1 **Updated comment #111 D2.2:**

2 Subject: Equation 33A-4:

109
110 [Figure 33-X1 illustrates the relationship between \$R_{pair_PD_max}\$ and \$R_{pair_PD_min}\$ effective resistances at the](#)
111 [PD PI as specified by Equation 33-X4 and the rest of the end to end pair to pair effective resistance components.](#)

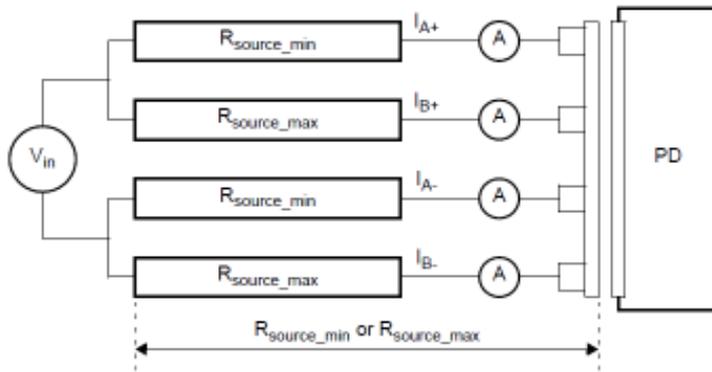
90
91 PDs that comply with Equation 33-X4 intrinsically meet unbalance requirements.

92 -Update equation 33-X4 constants as follows (Updates are due to: Changing 71W to 71.3W, final
93 updates of PD Vdiff to 60mV for Type 3 and Type 4, channel P2PRun changes made for D2.2)
94 -Update equation 33A-4 from " $R_{pair_pd_max} =$ " to " $0 < R_{pair_pd_max} \leq$ "

95
96
97
$$0 < R_{Pair_PD_max} \leq \left. \begin{array}{l} 2.170 \times R_{Pair_PD_min} + 0.125 \quad \text{for PD Type 3, Class 5} \\ 1.988 \times R_{Pair_PD_min} + 0.105 \quad \text{for PD Type 3, Class 6} \\ 1.784 \times R_{Pair_PD_min} + 0.080 \quad \text{for PD Type 4, Class 7} \\ 1.727 \times R_{Pair_PD_min} + 0.074 \quad \text{for PD Type 4, Class 8} \end{array} \right\} \Omega \quad (33-X4)$$

139 **Figure 33–37— I_{Con-2P} and $I_{Con-2P-unb}$ evaluation model**

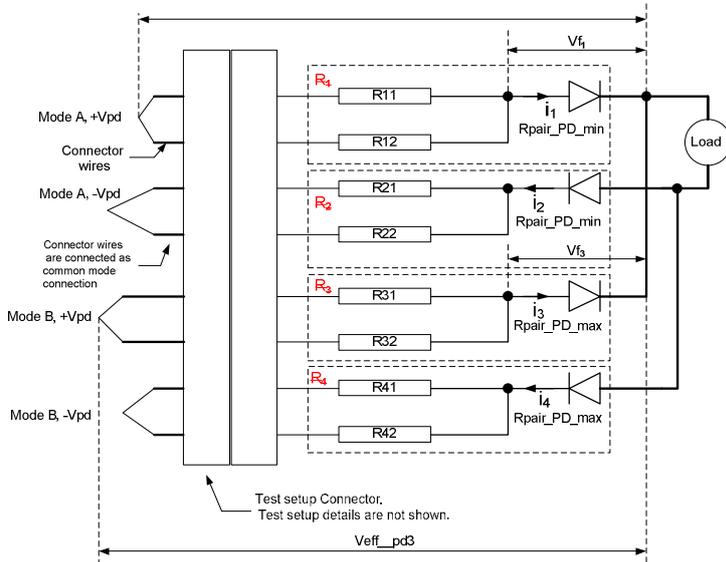
120 Under all operating states, dual-signature PDs shall not exceed ICon-2P as defined in Equation (33–8)
 121 for lon-ger than TCUT-2P min as defined in Table 33–18 on any pair when PD PI pairs of the same
 122 polarity are connected to all possible common source voltage in the range of VPort_PSE-2P through
 123 two common mode resistances, Rsource_min and Rsource_max, where
 124 $R_{source_max} = (-0.030 * R_{source_min} + 1.324) * R_{source_min}$, ~~$R_{source_max} = 1.186 * R_{source_min}$~~ , and
 125 Rsource_min are all possible resistances in the range of ~~0.145 0.168~~ Ω to ~~5.470 5.28~~ Ω as shown in
 126 Figure 33–37.

127
 128 Rsource_min and Rsource_max represent the Vin source common mode effective resistance that
 129 consists of the PSE PI components (RPSE_min and RPSE_max as specified in 33.2.8.5.1,
 130 VPort_PSE_diff as specified in Table 33–18, the channel resistance, and influence of RPair_PD_min
 131 and RPair_PD_max ~~specified in Annex 33A.5~~ as function of ~~total~~ system end-to-end unbalance).
 132 Common mode effective resistance is the resistance of two con-ductors of the same pair and their other
 133 components, which form Rsource, connected in parallel including the effect of the total system (PSE
 134 and PD) pair to pair voltage-difference. IA and IB are the pair currents of pairs with the same polarity.
 135 RPAIR_PD_min, RPAIR_PD_max ensures that along with any other parts of the system, i.e. channel (cables and
 136 connectors) and the PSE, the maximum pair current including unbalance does not exceed ICon-2P-unb
